**ADDENDUM NO. 03  
January 25, 2022**

To Drawings and Specifications dated December 17, 2021

**CLINE ELEMENTARY SCHOOL CAMPUS REPLACEMENT  
FOR FRIENDSWOOD I.S.D.**

Prepared by: PBK  
11 Greenway Plaza, 22<sup>nd</sup> Floor  
Houston, TX 77046-1104  
PBK Project No: 20380

# ARCHITECTURAL SITE PLAN

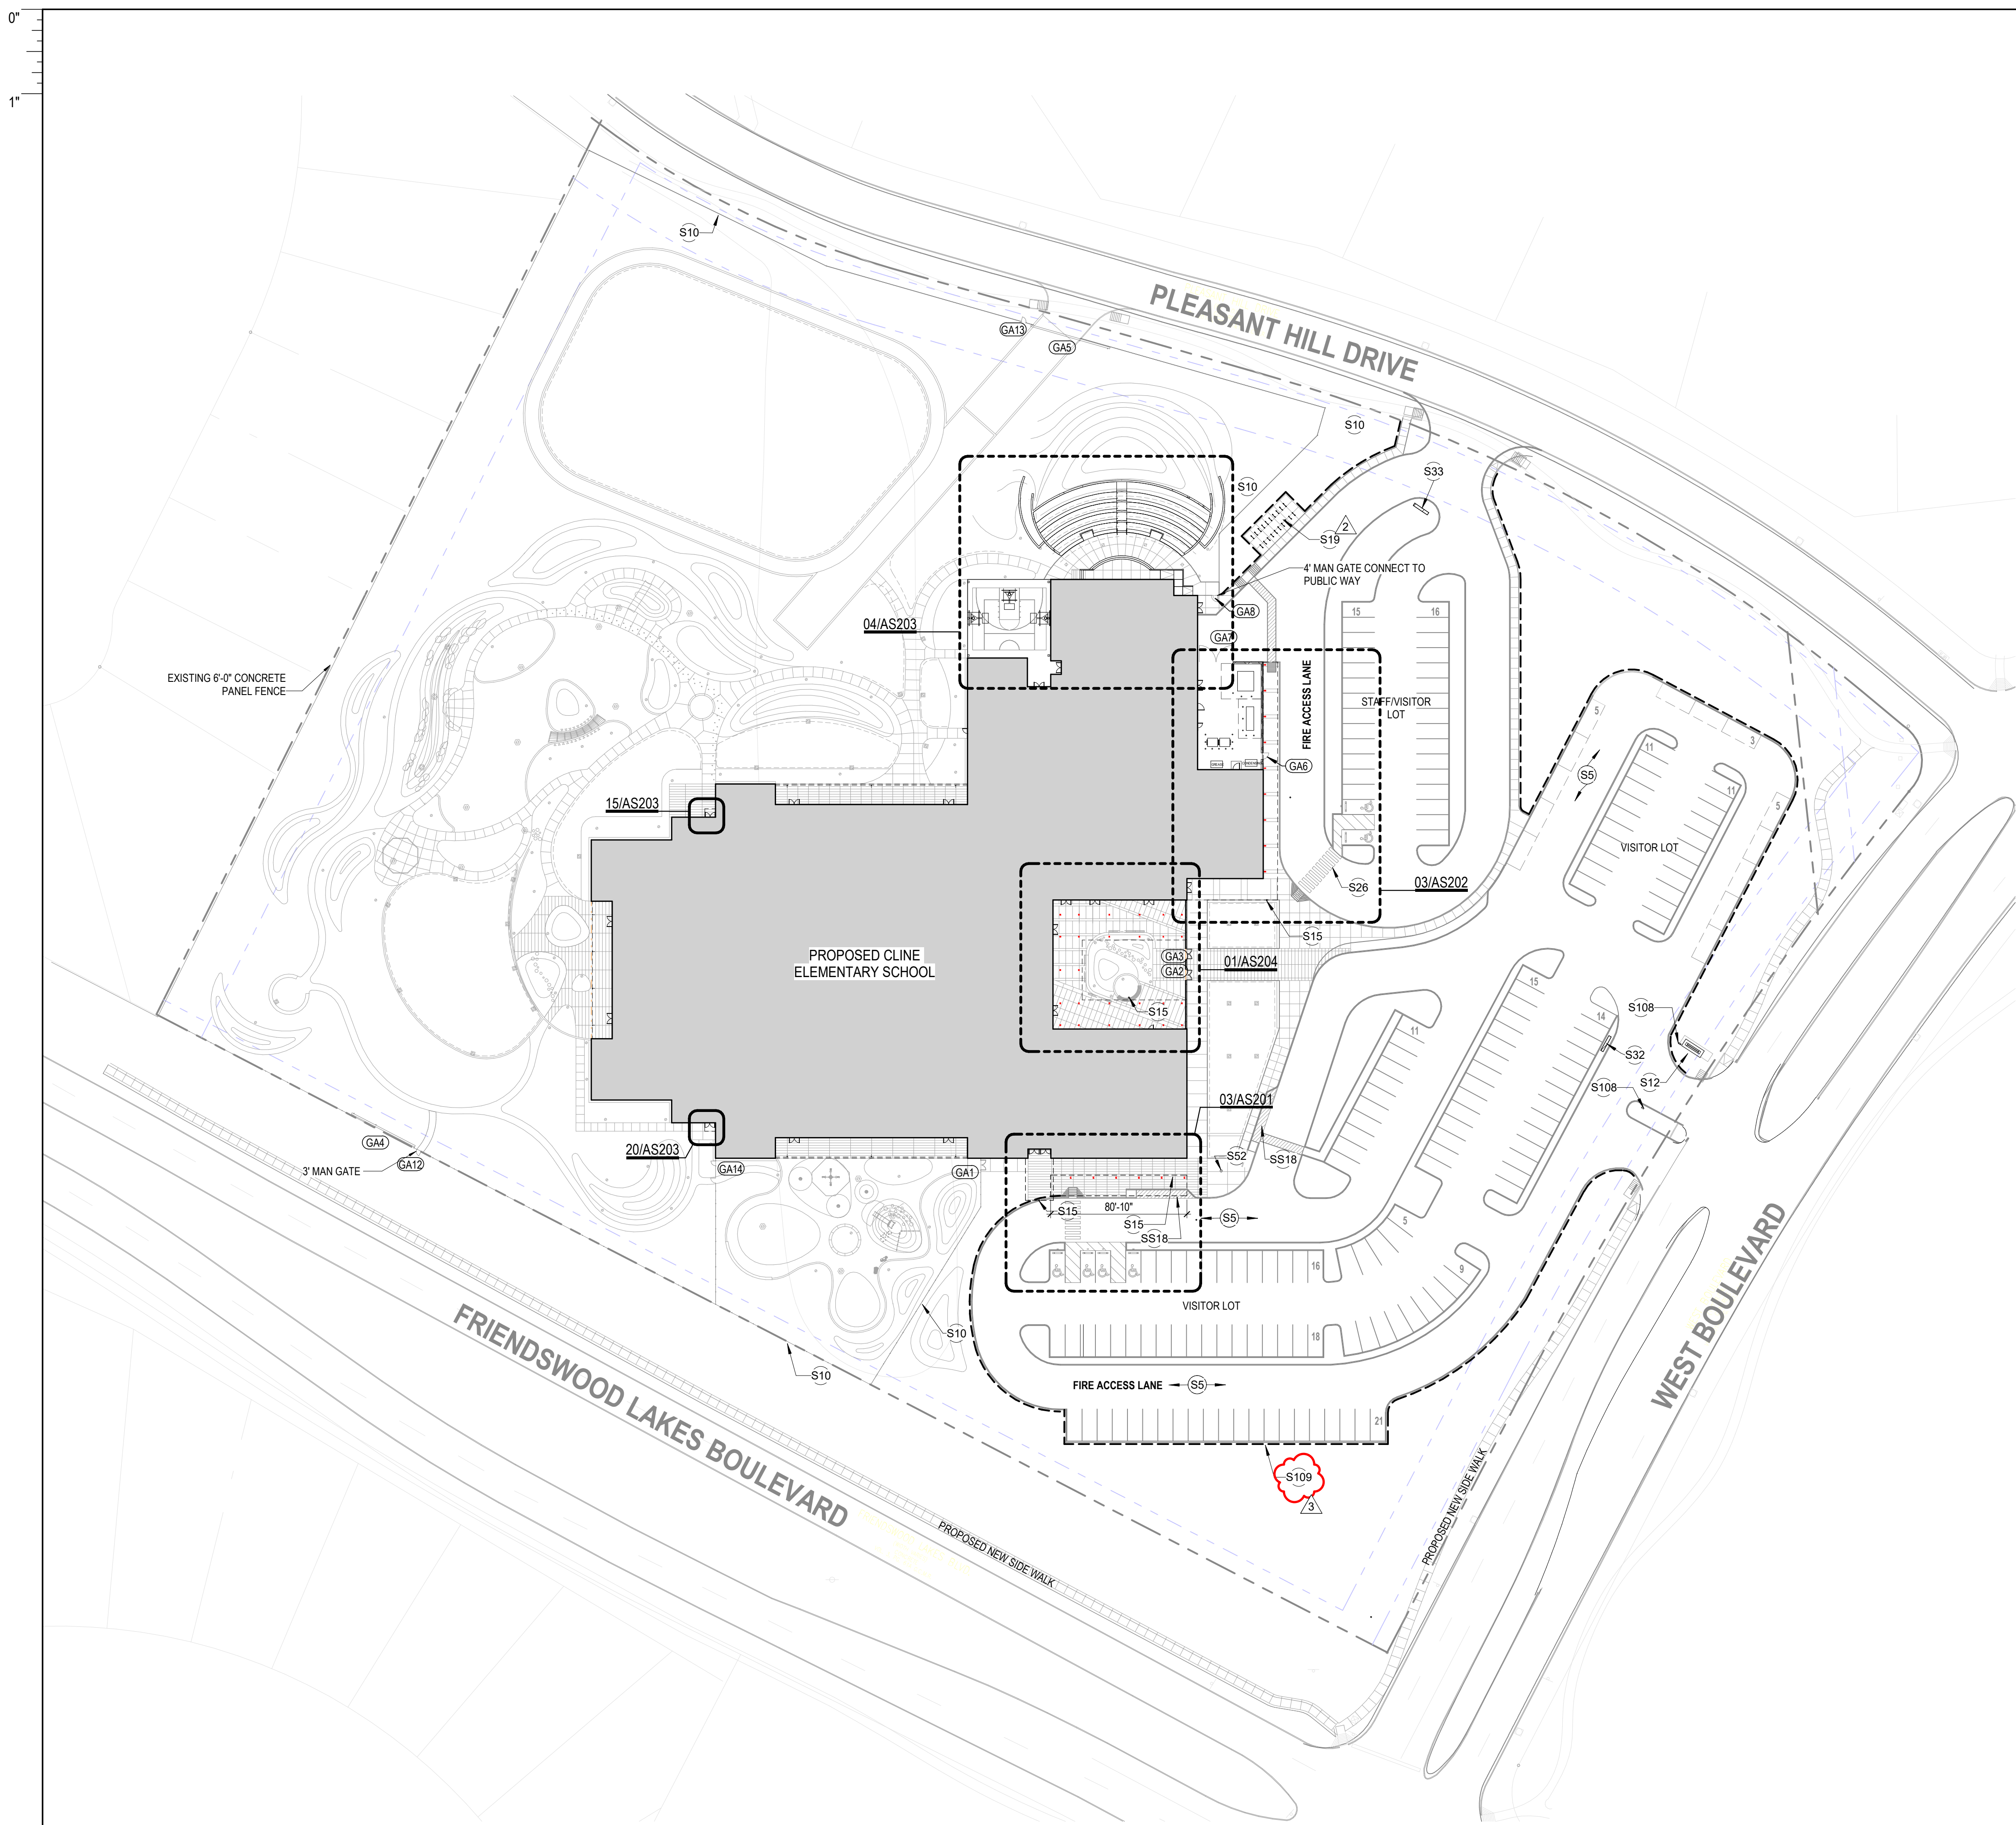
- Item No. 1 **AS 101 – ARCHITECTURAL SITE PLAN**
  - a. Clarified planting location along with parking perimeter.
- Item No. 2 **A-301 – ROOF PLAN**
  - a. Updated Detail 16 to include correct references.
  - b. Added details 10 thru 17.

KEYNOTE LEGEND	
NUMBER	DESCRIPTION
S5	CONCRETE DRIVE, RE: CIVIL
S10	6'-0" ORNAMENTAL FENCE
S12	MONUMENT SIGN W/ DIGITAL MARQUEE
S15	ALUMINUM COVER ABOVE
S19	20 BIKE RACKS (2 BICYCLE STORAGE PER EACH RACK UNIT) RE: SPECS
S26	PAINTED STRIPE, 4' WIDE TYP
S32	TRAFFIC SIGN, SIGN A RE: 05/AS302
S33	TRAFFIC SIGN, SIGN B RE: 05/AS302
S52	30'-0" TALL FLAGPOLE
S106	AUTOMATED OR IDENT. PICK-UP SYSTEM, VERIFY EXACT LOCATION WITH ARCHITECT
S109	DASHED LINE INDICATES WAX LEAF LIGUSTRUM ALONG WITH PARKING PERIMETER, REFER TO LANDSCAPE
SS18	RAISING RAMP LANDING ZONE, ACCESS AISLE
